Genesis Solar Energy Project - Docket Number 09-AFC-8

SUBJECT: Revisions to Jurisdictional Waters for the Genesis Solar Energy Project

Revisions to Jurisdictional Waters
Genesis Solar Energy Project
March 13, 2010

WATERS EVALUATION
INDEX MAP

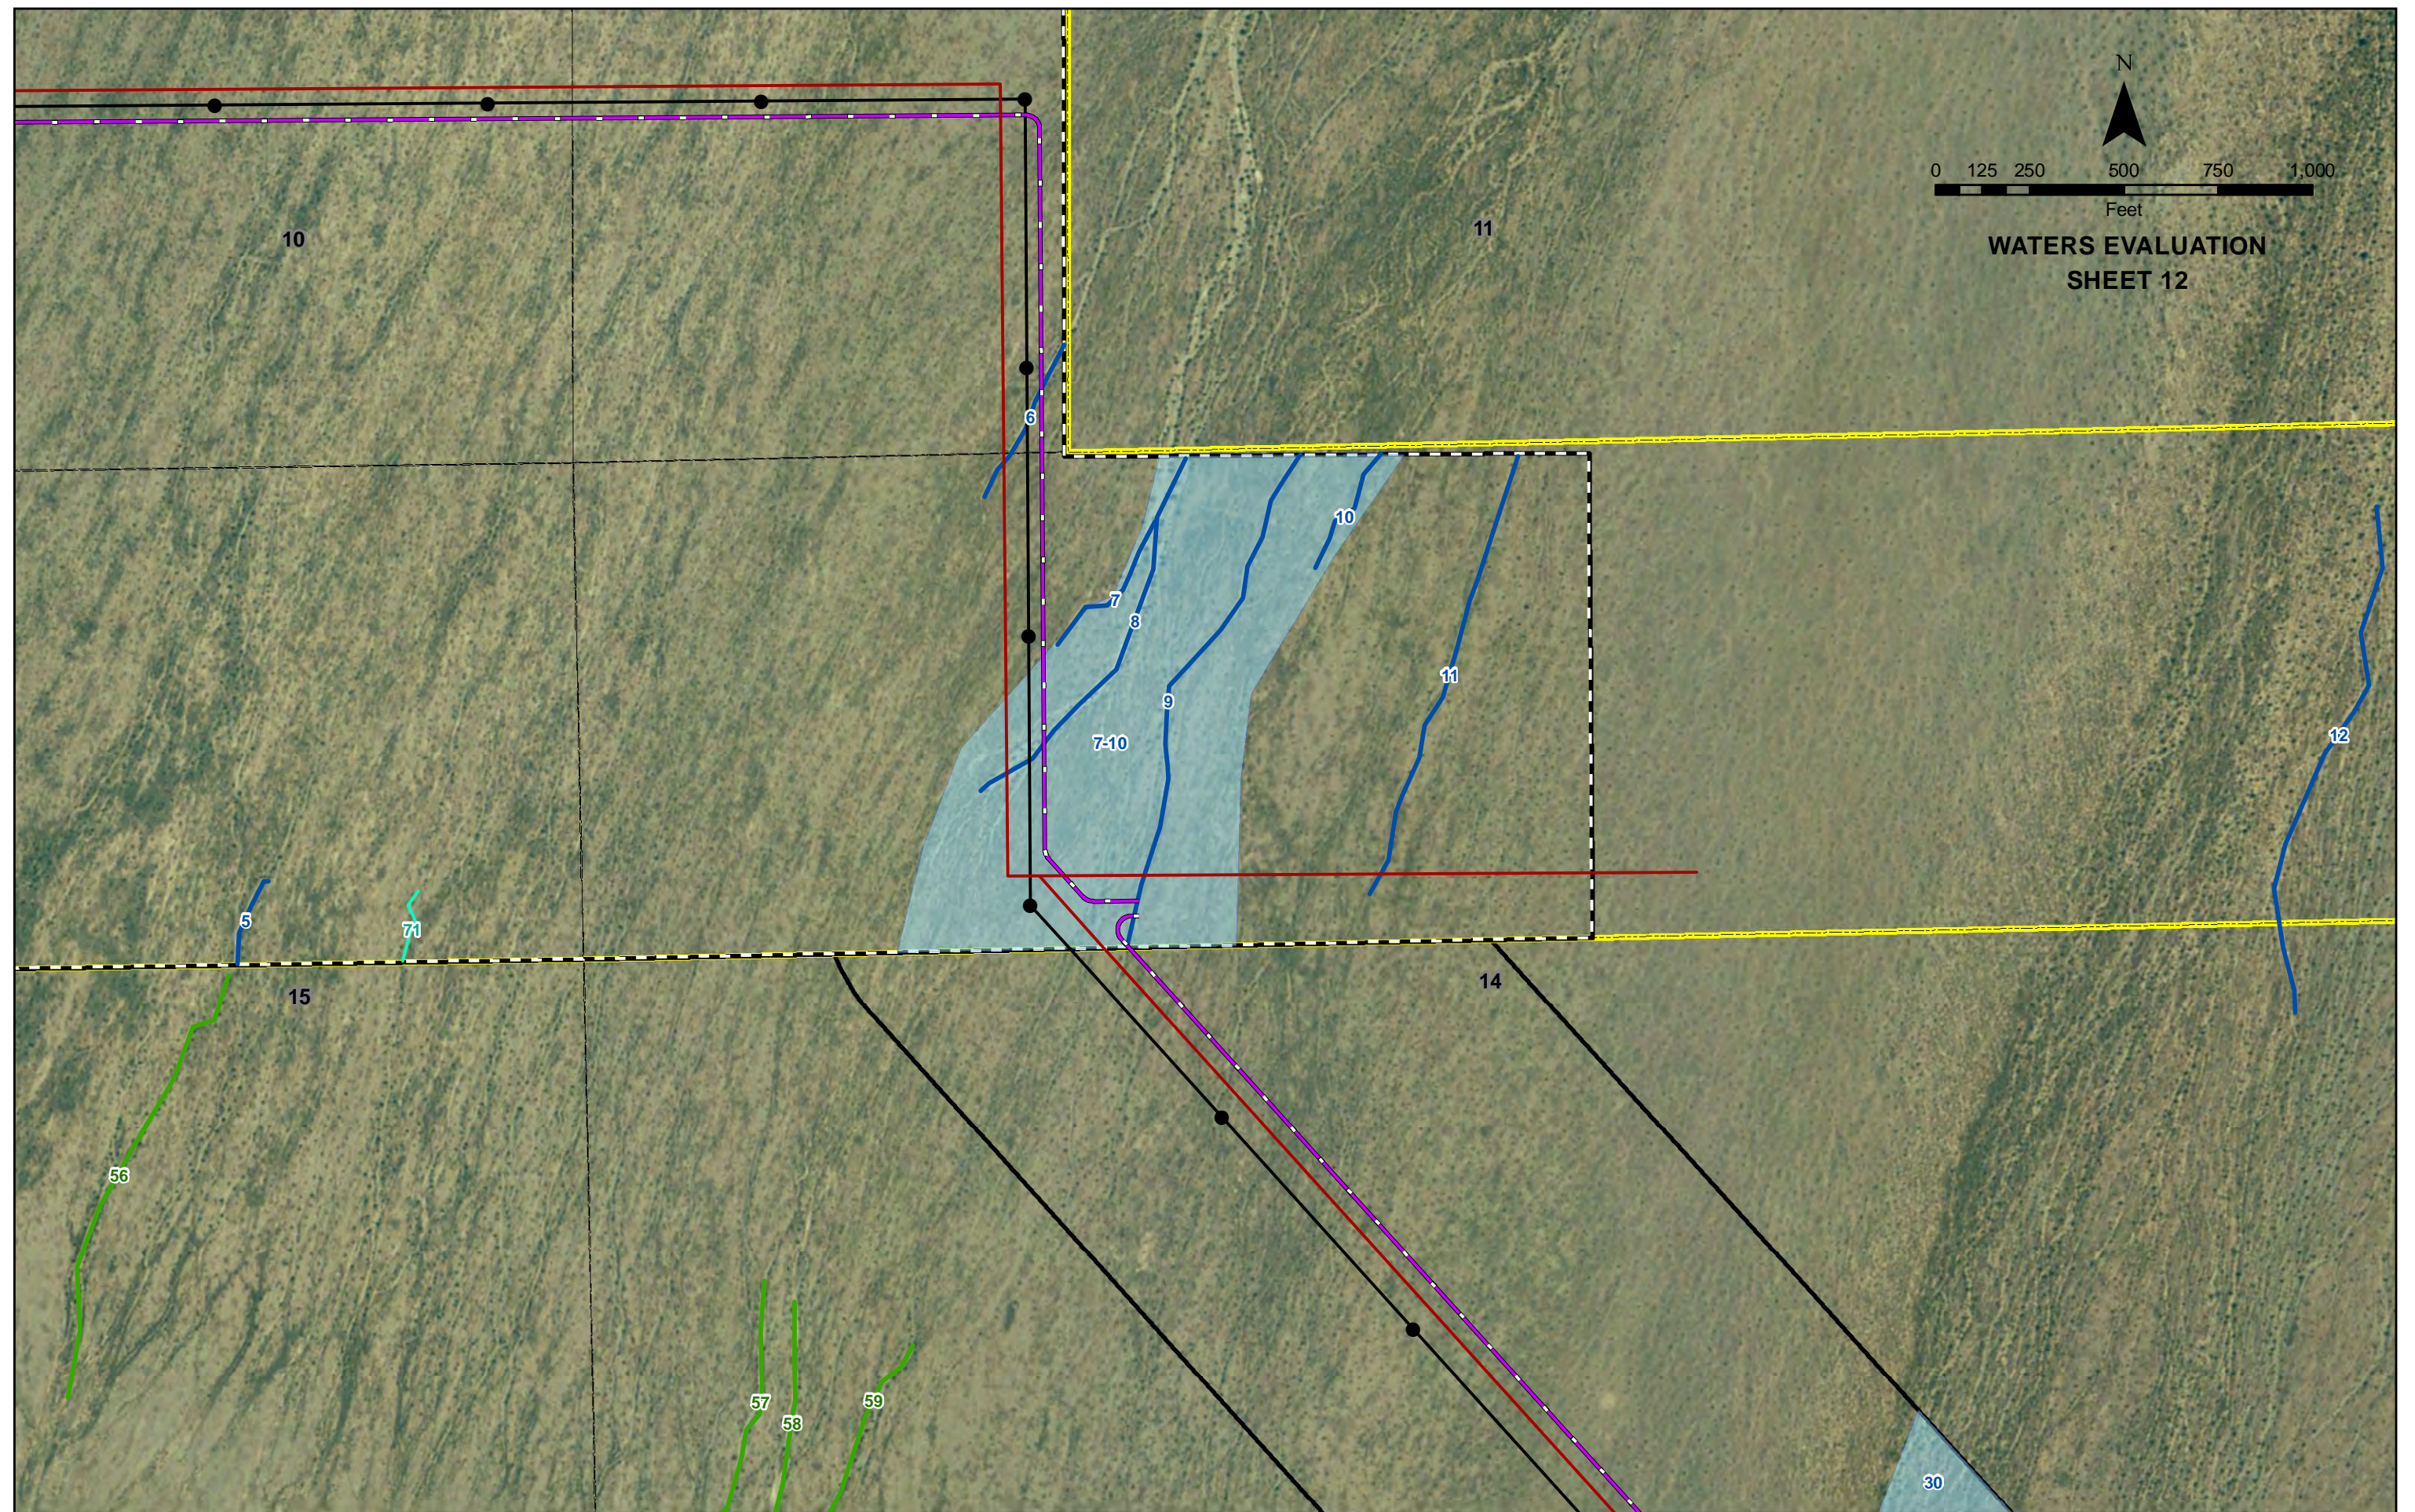
Per your request, Genesis Solar has revised the appropriate table and figures to depict the drainages you delineated in the field on February 17, 2010. Specifically, updates have been made to Appendix C. *Washes and Microphyllous Vegetation Directly Impacted by Project Facilities* and Map Sheets 2, 4, 5, 11, and 12 of the *Jurisdictional Waters and Wetlands Report* submitted in January 2010. The added drainages result in an additional 7.80 acres of permanent impact, 0.00 acres of temporary impact, 2 additional impacted trees (ironwood trees), and 0.00 acres of microphyll vegetation areas. The area permanently impacted by the Project is now 72.64 acres.
